**Ref:** SSD-78775458

**RE: SUBMISSION TO SSD-78775458, RESIDENTIAL FLAT BUILDING WITH IN-FILL  
AFFORDABLE HOUSING  
Address: 3-9 Park Avenue, Gordon**

### Ku-ring-gai Council's objection to SSD-78775458, Residential Flat Building with In-fill Affordable Housing at 3-9 Park Avenue, Gordon

**Figure 1: Building height blanket (Drawing No. PTW-DA-Q100010, Rev A, prepared by PTW and dated 1 April 2025)**

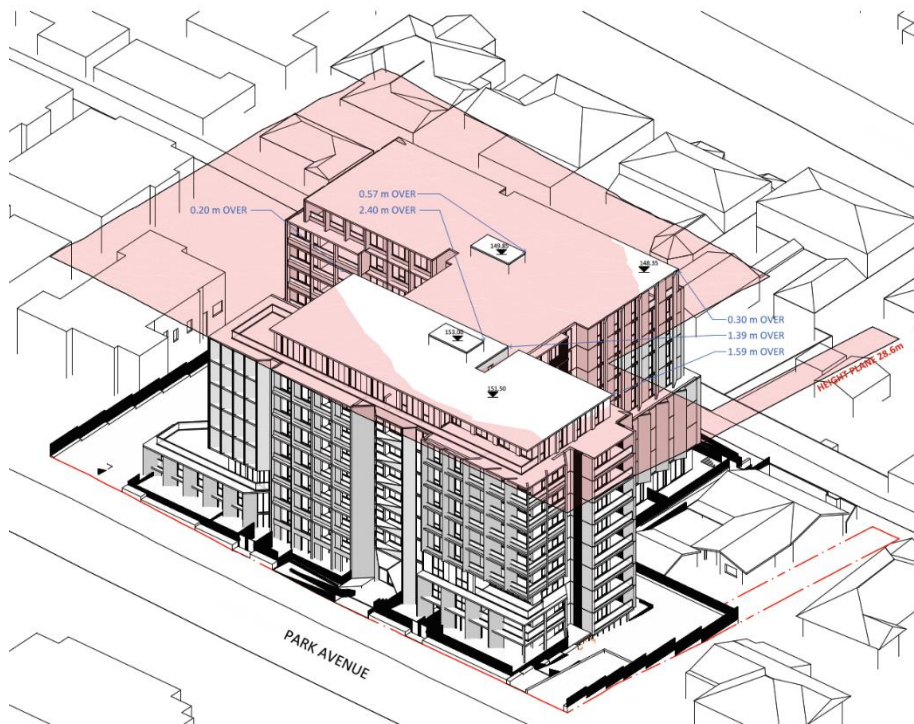
The proposal seeks a maximum building height of 31m, measured to top of the lift overrun in Building A which exceeds the maximum building height control by 2.4m, equating to a variation of 8.39%.

Other building elements on the upper levels of Buildings A and B, also exceed the maximum building height development standard as shown in **Figures 1 and 2** below.

**Figure 7: Alternative location for visitor bicycle parking**

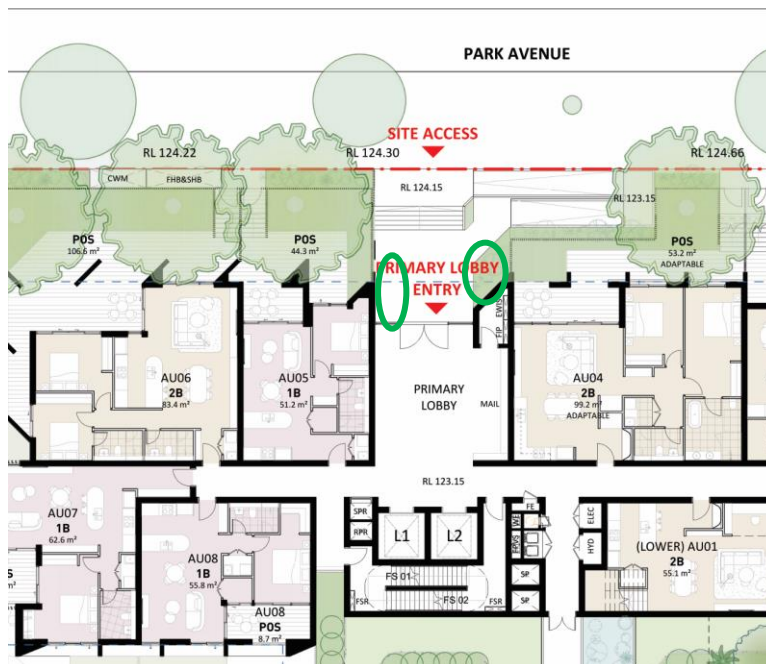
Visitor bicycle parking is proposed to be located on the Basement 01 level. There are similar ramp gradient access issues for visitor bicycles as that noted above. Given the additional practicality of visitors entering the secure parking area to access the bicycle parking from the main entry ramp, it is recommended that the visitor bicycle parking be relocated adjacent to the Primary Lobby/Entry area from Park Avenue shown in green on the Upper Ground Floor plan (**Figure 7** below):

The design of the pedestrian ramp leading from street level to the Primary Lobby/Entry area should ensure adequate access for people to dismount and wheel their bicycles between street level and the Primary Lobby/Entry area.

**Figure 8: Sight triangle required to be shown on plans to demonstrate compliance with AS2890.2**

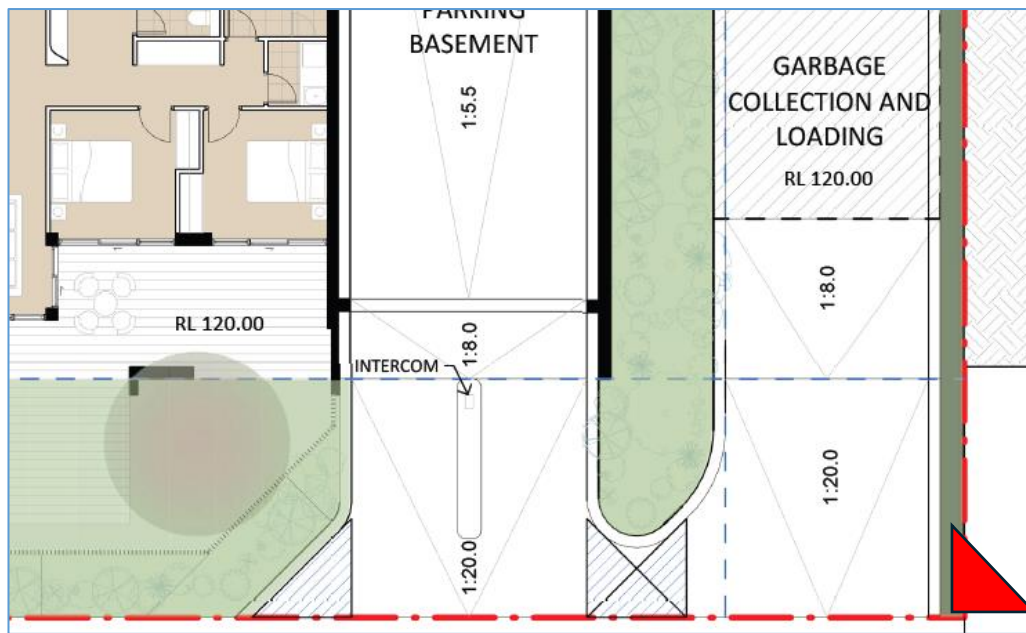
There is a non-compliance in the provision of the 2m x 2.5m sight triangle as per clause 3.4.5 of AS2890.2 (shown in red in **Figure 8** below):

It is unclear whether a compliant sight triangle can be provided given the proximity of the loading bay to the side boundary.
